**STAFF REPORT**  
**COMMUNITY DEVELOPMENT DEPARTMENT**

HEARING DATE: 12/7/2021  
 TO: Mayor & City Council  
 FROM: Alan Tiefenbach, Associate Planner  
 208-884-5533  
 SUBJECT: H-2021-0044, H-2021-0005  
 Elderberry Estates Subdivision  
 LOCATION: 1332 N. Meridian Rd

This is a request to rezone from C-C to O-T and a Short Plat of four lots to allow four duplexes.

A. Short Plat (date: ~~6/23/2021~~ 10/7/2021)

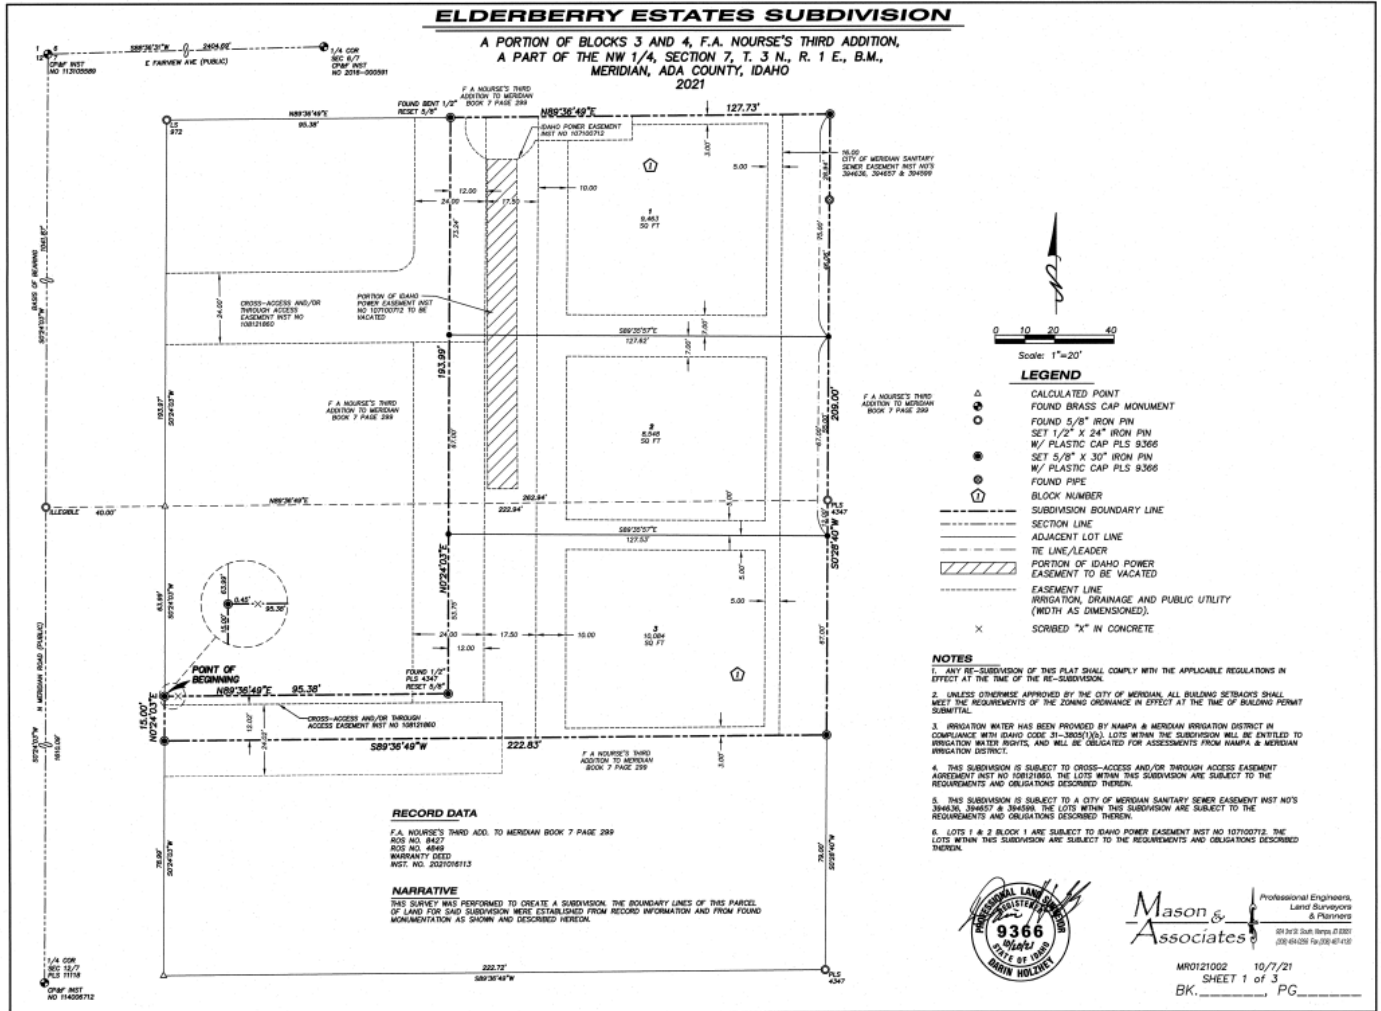
UDC 11-3A-17 requires a minimum width of 5 ft. for sidewalks. **As a condition of approval, the applicant should be required to construct a 5 ft. wide sidewalk along the northern side of the southern driveway access (which is on the subject property). Also, staff recommends the applicant work with the adjacent property owners at 1324, 1404 and 1414 N. Meridian Rd to improve and widen all sidewalks entering the property to meet the required 5 ft. width. Also, to provide a better pedestrian connection from N. Meridian Rd to the duplexes, Staff recommends as a condition of approval that sidewalk extensions be provided across the private drives that distinguish a pedestrian connection from the vehicular driving surfaces through the use of pavers, colored or scored concrete, or bricks as required by UDC 11-3A-19-B-4.**

The site plan indicates the applicant intends to relinquish an Idaho Power Easement along the front of the duplexes. The applicant will be required to provide proof of this relinquishment prior to signature of the City Engineer on the short plat.

4. The sidewalk along the north side of the southern driveway shall widened to 5 ft. in width. The applicant should work with adjacent property owners to widen the other sidewalks on both sides of the southern and northern driveways to 5 ft. in width.

6. The short plat prepared by Mason and Associated, dated 6/23/21, shall be revised as following:
  - a) Prior to City Engineer's signature on the plat, the applicant shall provide proof of the relinquishment the Idaho Power Easement.

- b) Add cross access easement Instr. No 2020-148053 to Note 4.
7. Prior to signature of the final plat by the City Engineer, the applicant shall provide a letter from the United States Postal Service stating that the applicant has received approval for the location of mailboxes. Contact the Meridian Postmaster, Sue Prescott, at 887-1620 for more information.

C. Building Elevations (date: 7/20/2021)

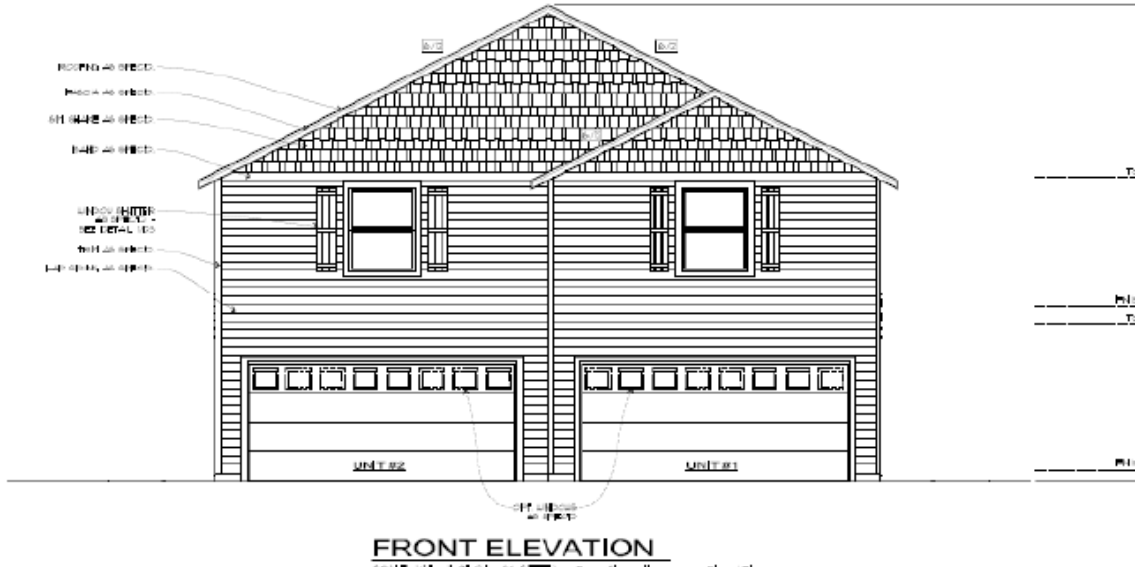
Conceptual elevations were provided with this application. The elevations indicate duplexes with pitched roofs, fishscale accents, shuttered windows with lintels and windowed garaged doors. As is required by the O-T zoning district, the duplexes are at least two-stories, although the elevations do not indicate whether the minimum required 35' height is met.

This project is near the downtown core and is being proposed for Old-Town zoning. Due to the visibility of these two story-buildings, design is critical to this project. The ASM for residential requires visually heavier and more massive elements or materials, such as stone or masonry, primarily at the base of buildings, and lighter elements and materials such as siding. Also, the ASM states primary building entries must be clearly defined using any unique combination of architectural elements, materials, or façade modulation meeting other architectural standards in the Manual. At the time of design review, the elevations should provide front porches over the front doors, overhangs matching the rooflines or porches over the garage doors, and a heavier accent material around the base of the buildings.

1. Administrative design review is required prior to building permit for all new attached residential structures containing two (2) or more dwelling units. Elevations should include at least two field materials, accent materials, a heavier accent material around the base of the buildings, covered porches, and overhangs matching the rooflines or porches over the garage doors.
